RHODE ISLAND DEPARTMENT OF TRANSPORTATION

1R Improvements to Rt. 107

NOTICE TO PROSPECTIVE BIDDERS

ADDENDUM NO. 2 Prospective bidders and all concerned are hereby notified of the following changes in the Plans, Specifications, Proposal and Distribution of Quantities for this contract. These changes shall be incorporated in the Plans, Specifications, Proposal and Distribution of Quantities, and shall become an integral part of the Contract Documents.

LOCATION PLAN NO. 2

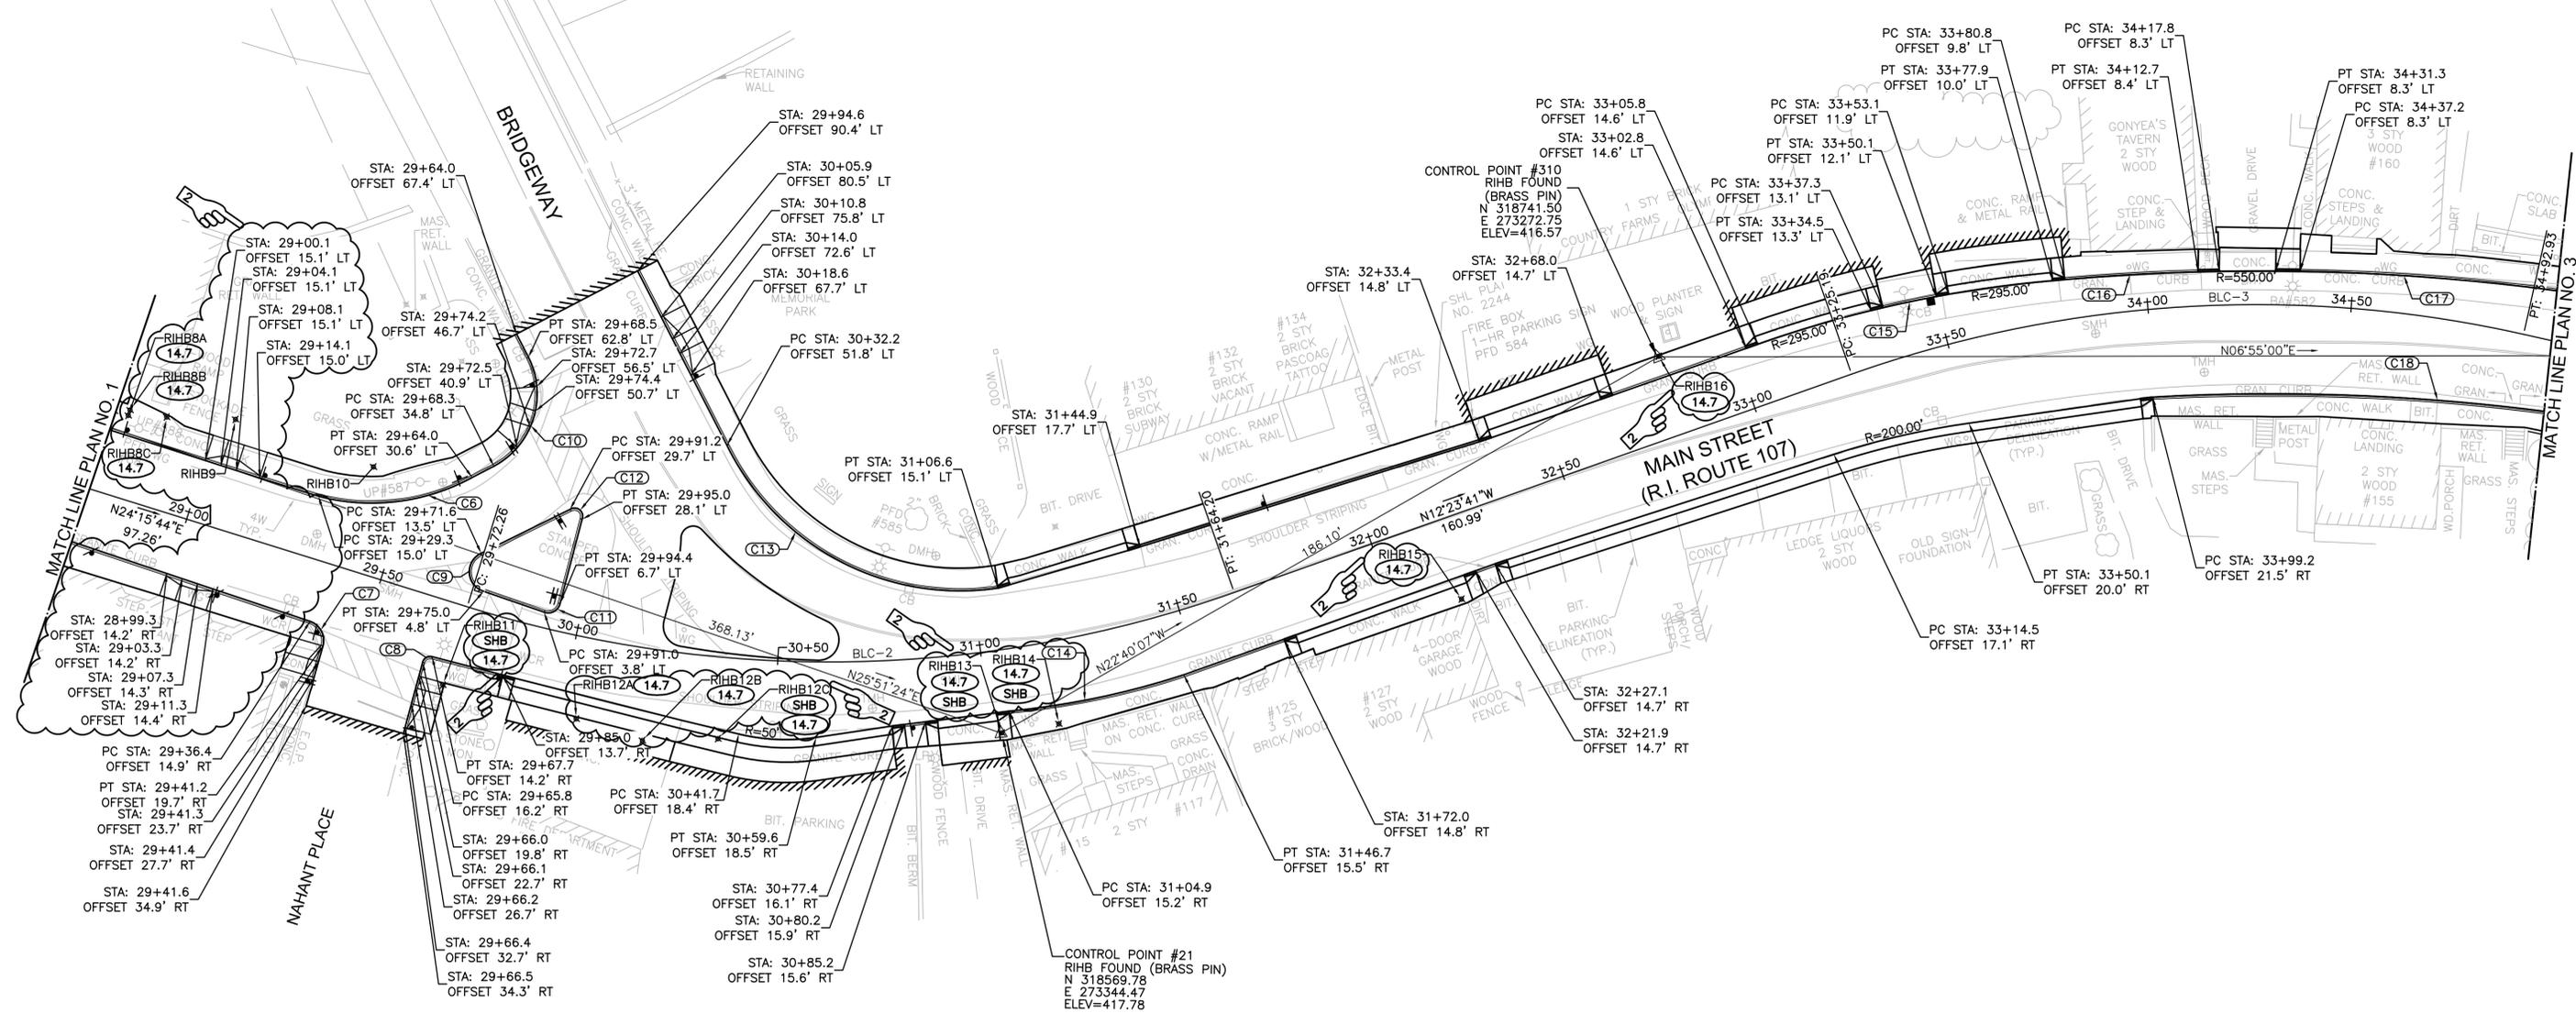
Delete Sheet No. 59 - Location Plan No. 2 in its entirety and replace it with Sheet No. 59 - Location Plan No. 2 (R-1) attached to this Addendum No. 2. Curb ramp locations have been revised and highway bounds have been revised/added.

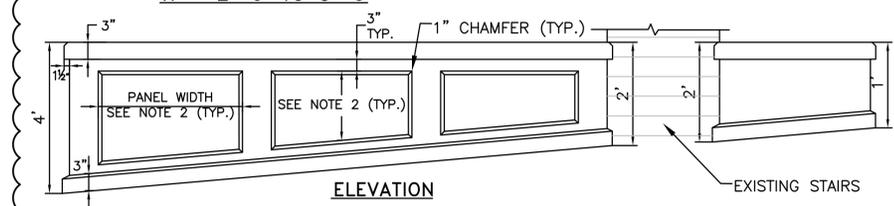
Delete Sheet No. 111 - Details Sheet No. 2 in its entirety and replace it with Sheet No. 111 - Details Sheet No. 2 (R-1) attached to this Addendum No. 2. The concrete retaining wall (modified) detail has been added.
